**Response to Revised Planning Proposal – 193-199 Rocky Point Road, 66-68 Ramsgate Road and 2-6 Targo Road, Ramsgate**

Elton Consulting, a WSP Company has been engaged by Georges River Council (Council) to undertake an independent assessment of a Planning Proposal for the site located at 193-199 Rocky Point Road, 66-68 Ramsgate Road and 2-6 Targo Road, Ramsgate, referred to as Ramsgate Village (the Site).

**Preliminary Assessment Planning Proposal - 193-199 Rocky Point Road, 66-68 Ramsgate and 2-6 Targo Road Ramsgate**

**Figure 1** Line of Sight Diagram

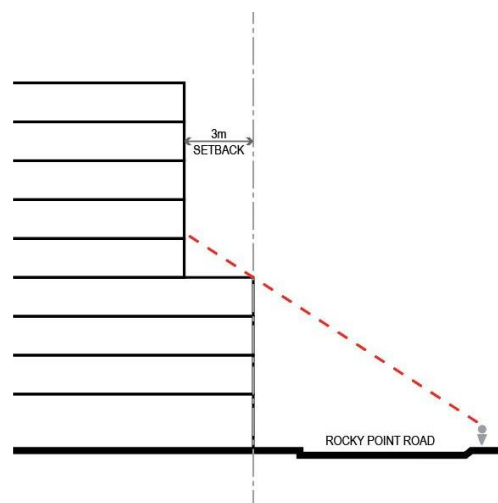
- Stepping the proposed street wall of 6 storeys at the corner down to 4 storeys towards the centre of the site has partially resolved previous concerns raised relating to street wall heights. Notwithstanding, the overall bulk of the building has not been reduced as the proposal retains a 9 storey tower on Rocky Point Road and along Targo Road. A 3 metre setback is not sufficient for the tower form to be recessed from the perspective of a pedestrian on Rocky Point Road, as illustrated by **Figure 1** below. At the theoretical eye height of 1.8m, the entire bulk of the tower element will be visible from the public domain. The minor reduction in the height of the street wall alone is not considered to be an adequate response as the overall bulk and scale of the development has not been reduced. While it is acknowledged the street wall height has been reduced, the setbacks of the upper levels are not considered sufficient to ensure compatibility with the surrounds to reflect the local centre scale.

- The revised architectural plans should show the original street wall height proposed to illustrate the extent of reduction proposed.
- The revised concept does not include an elevation/building envelope diagram along Ramsgate Road and as such it is unclear if the height along this elevation has been altered as a result in changes to the street wall height on Rocky Point Road. Further consideration of the height along this elevation is required.

*Note: Any revised set of plans should include height in metres for the proposed scheme in addition to identifying the number of storeys.*

**Figure 6:** Application of the setbacks required for basements - with lower density interface

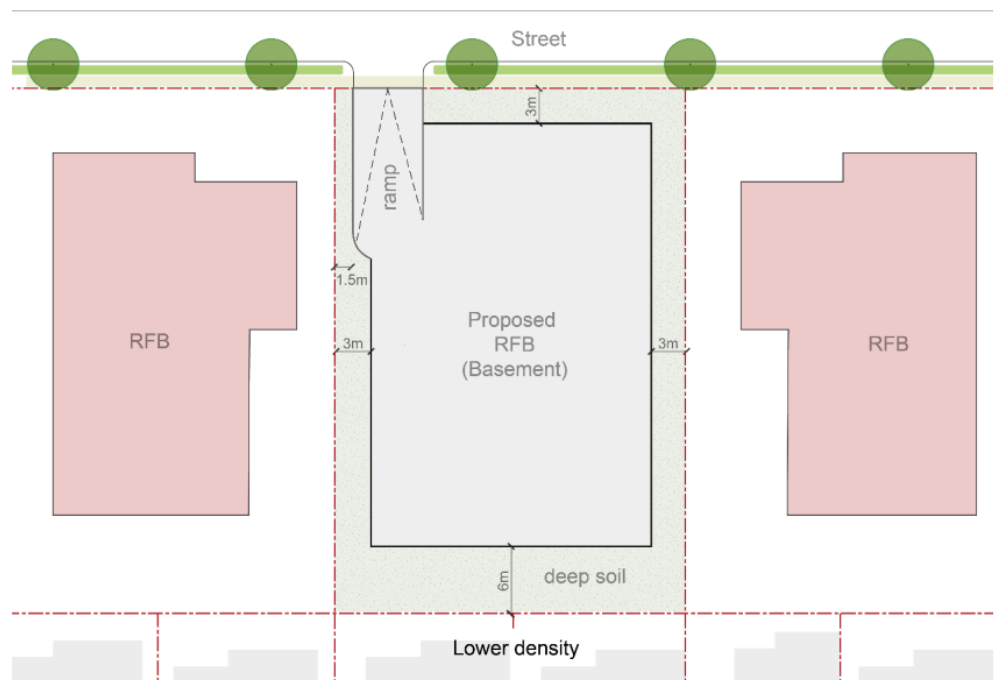
- Notwithstanding the above, the complete absence of deep soil landscaping within the concept scheme remains unaddressed and does not result in a positive design outcome for the public domain or surrounding residential properties.

- GRDCP 2021 provides objectives and controls to ensure basements within mixed use developments and residential flat buildings are designed to allow for adequate deep soil landscaping. These objectives and controls have been reproduced below.

- 1. Basements are to be set back a minimum of 3m from the site boundaries*
- 2. The basement setback areas are to be deep soil areas as defined in the Apartment Design Guide.*
- 3. Driveways and driveway crossings are to be located a minimum of 1.5m from a side boundary.*
- 4. Where a development site shares a boundary with a lower density zone (i.e., R2 or R3 zones), the minimum setback of the basement is to be 6m from the boundary with the lower density zone (refer to Figure 6 below).*
- 5. The 6m basement setback at a zone boundary is to be planted to provide a vegetated landscape buffer between the development and adjoining lower density development. Planting is to include trees that achieve a minimum mature height of 6.0m. Under canopy planting is to include lower scale planting that provides a visual buffer between developments and creates the desired landscape buffer.*

- Given the above, the Proposal is to be reconsidered and amended to provide a greater extent of deep soil landscaping. A reduction in the basement in accordance with the setbacks outlined above will be required to ensure deep soil landscaping can be provided on site.
- The use of planting on structures will only be considered as an alternative to deep soil landscaping if these areas are minimum 6 metres in dimension (i.e. at least 6 x 6 metres) in accordance with the ADG requirement to provide a conducive environment for the growth of mature canopy trees. Planting on structures with extensive soil depths of at least 1-1.5 metres are only acceptable when they are provided in conjunction with genuine deep soil zones on the western boundary.
